2. 11 Mall Road - Game On & Loretta's Last Call

PLANNING BOARD AGENDA FOR JANUARY 13, 2026 - 7:00 PM

Below please find our responses comments discussed in our December 9, 2025 meeting and at the PB meeting. Below please find each comment followed by our response in **bold.**

LYONS GROUP RESTAURANT
AT THE MALL AT ROCKINGHAM PARK
PLANNING BOARD SUBMISSION

Project No.	Drawing No.
151041901	VT901
Date: OCTOBER 23, 2025	
Drawn By: BAL	
Checked By: ICW	Sheet 1 of 1

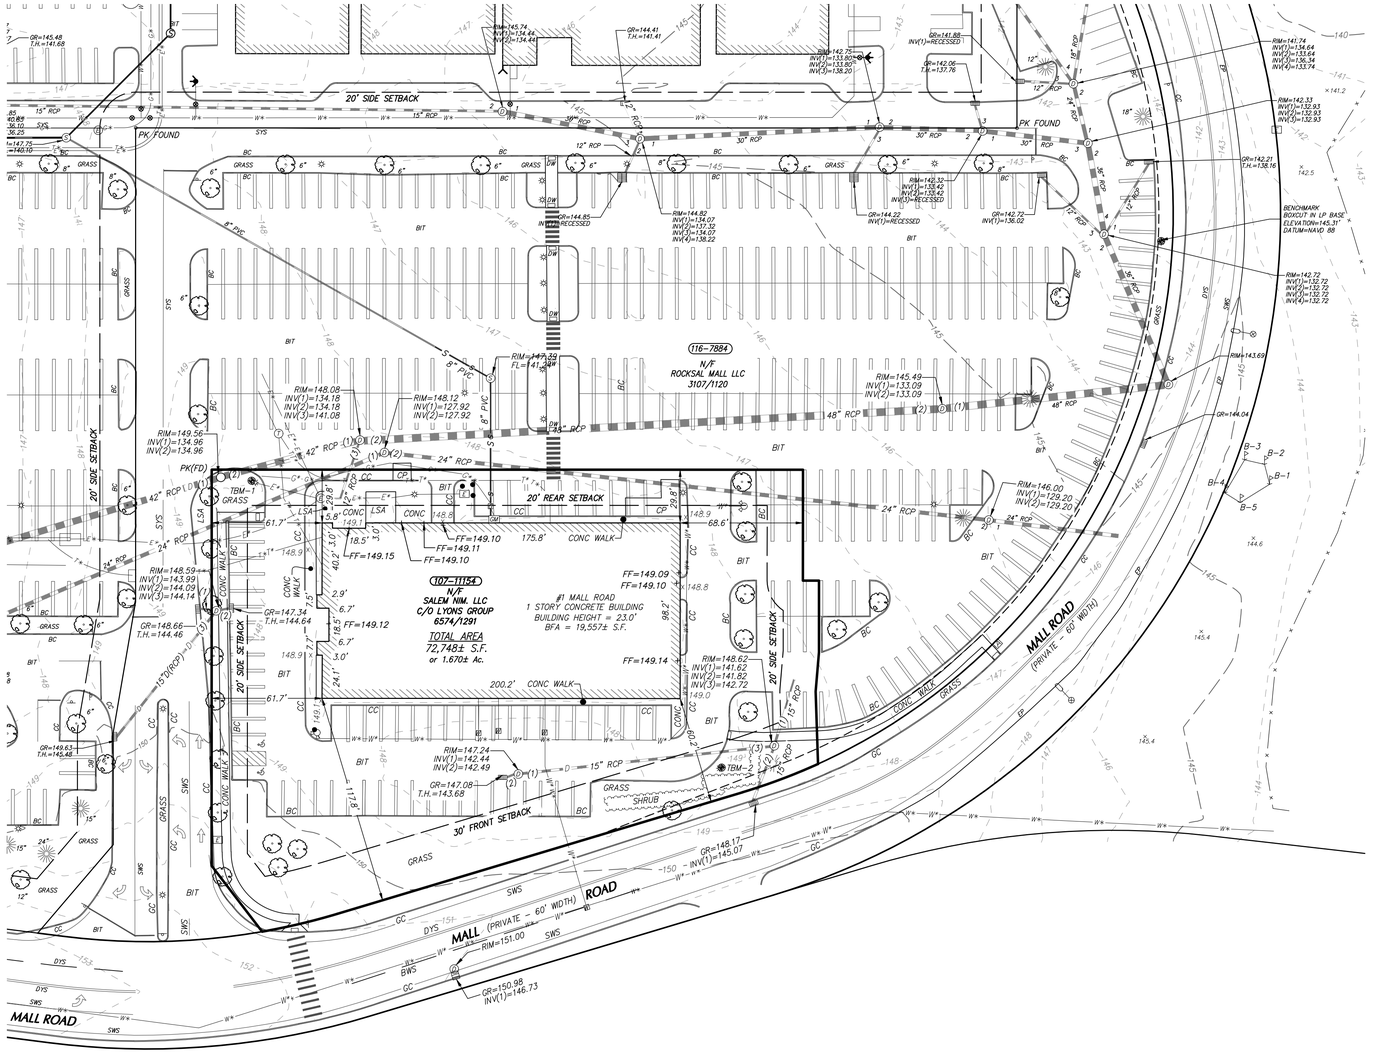
- Eliminate zoning table on Existing Conditions Plan

COMMENT RESPONSE: Zoning Table has been removed from VT901.

EXTERIOR ELEVATIONS

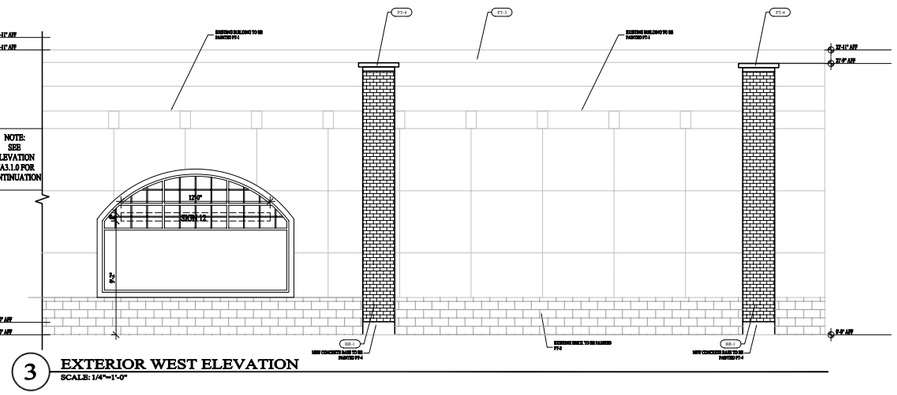
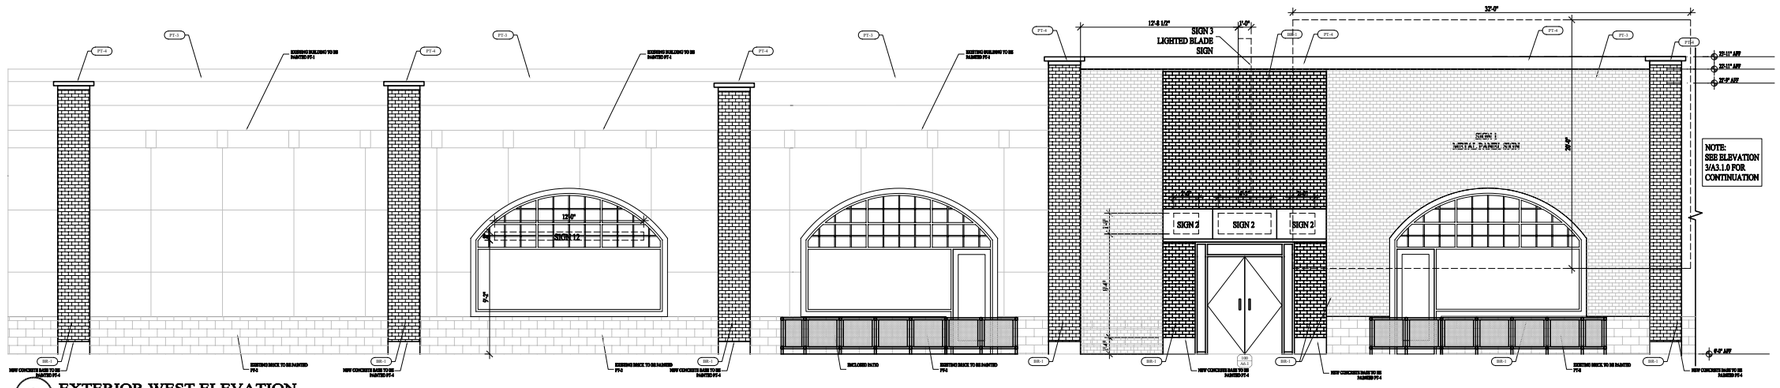
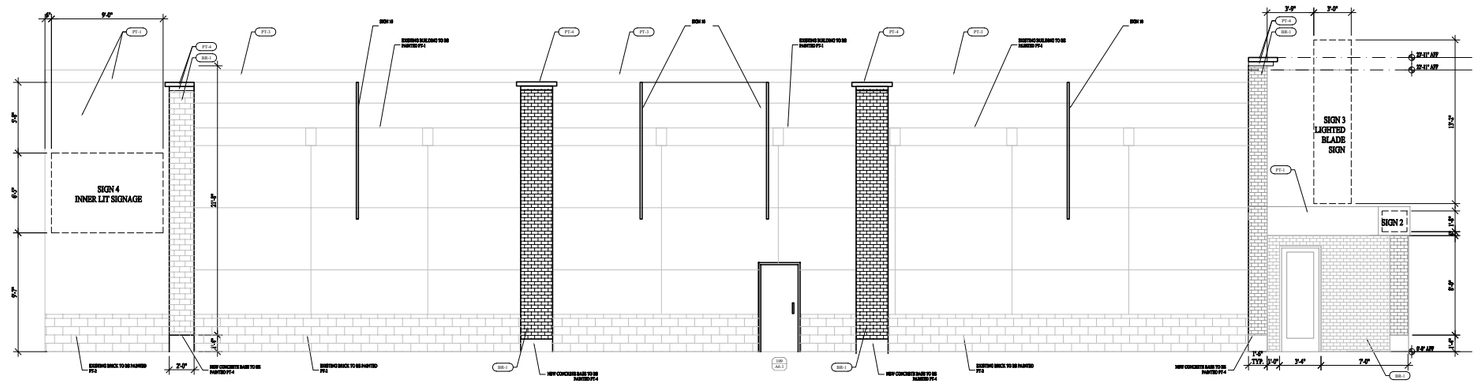
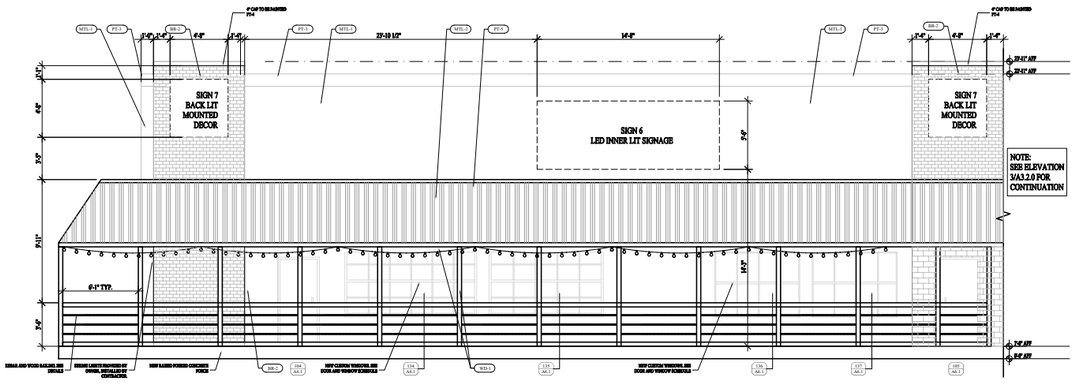
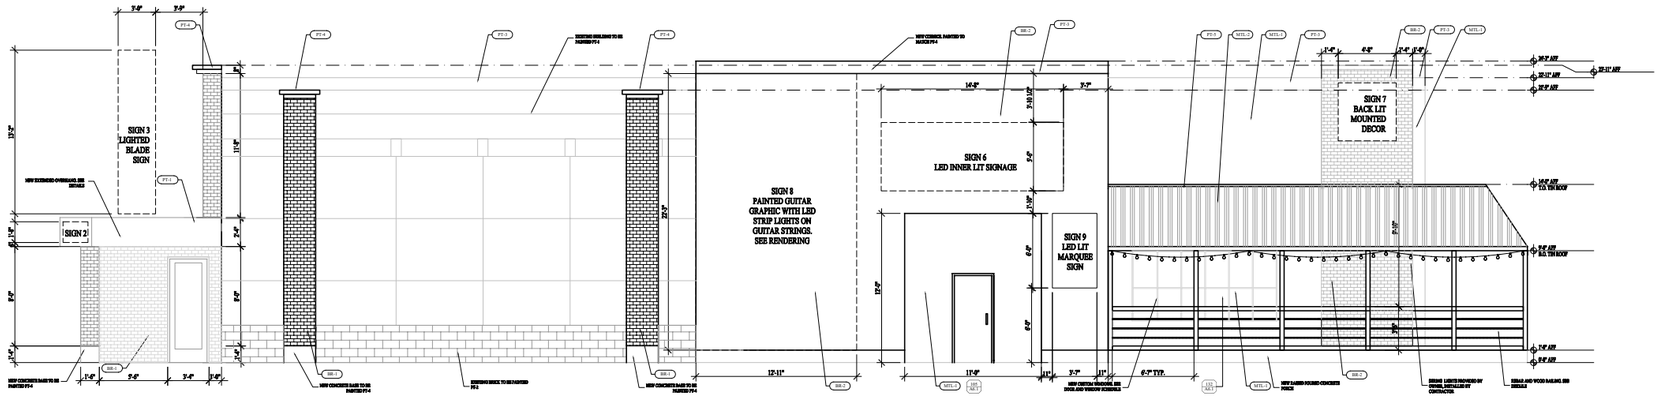
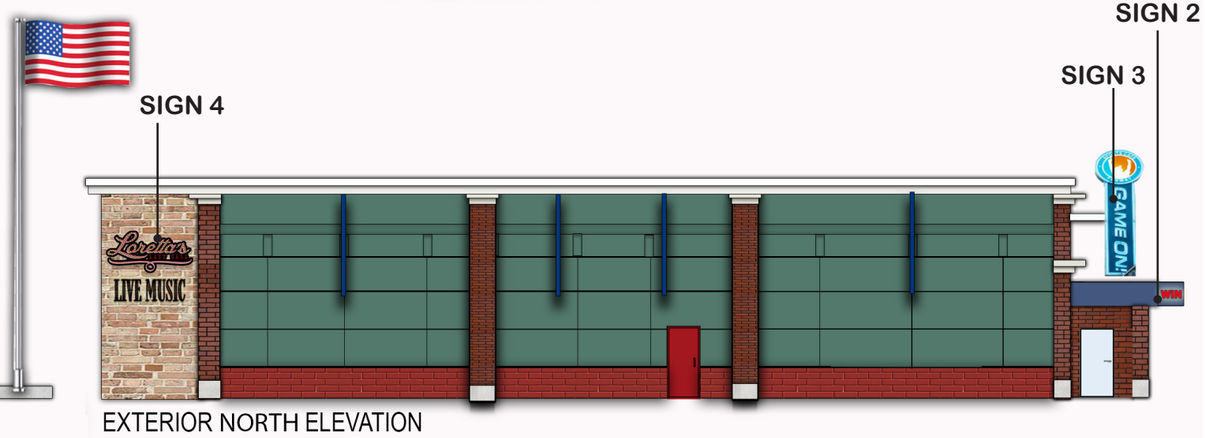
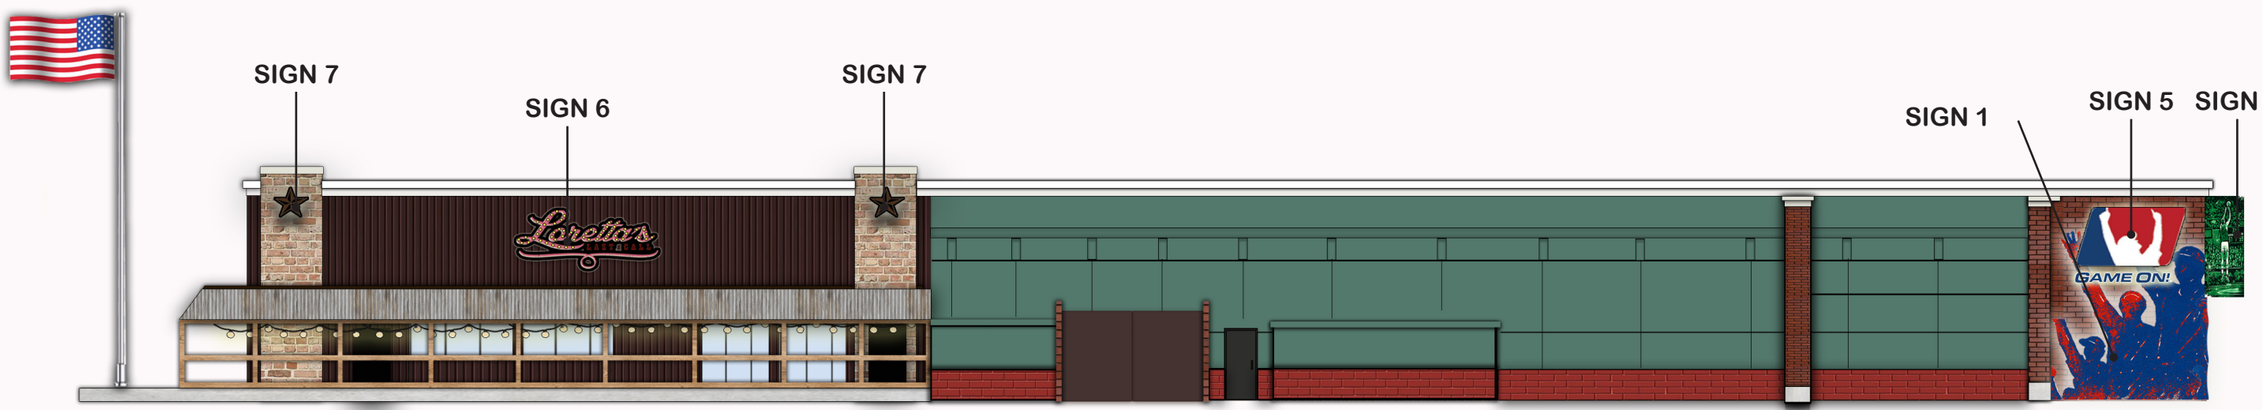
- Elevations:
  - Add legend – materials and color

fence; adding new brick for equipment storage and dumpster enclosure. Proposed modifications are attractive and welcomed improvements however building has blank walls on large portions of western, northern and eastern facades and eliminated transparency on western facade Elevations should still be revised to better comply with Site Plan Regulations and Design Guidelines (see excerpts attached) – specifically to reduce blank walls, increase transparency, vary roofline; dumpster enclosure should be revised to match building."

COMMENT RESPONSE: **Additional page has been added to the plans with the legend.**

COMMENT RESPONSE: This concern was addressed by adding the large window on either side of the entrance as well as two additional large windows beyond those two windows that are decorative. In addition, we have added banners on the North side of the building as well as an additional pilaster on the east face behind the equipment enclosure.
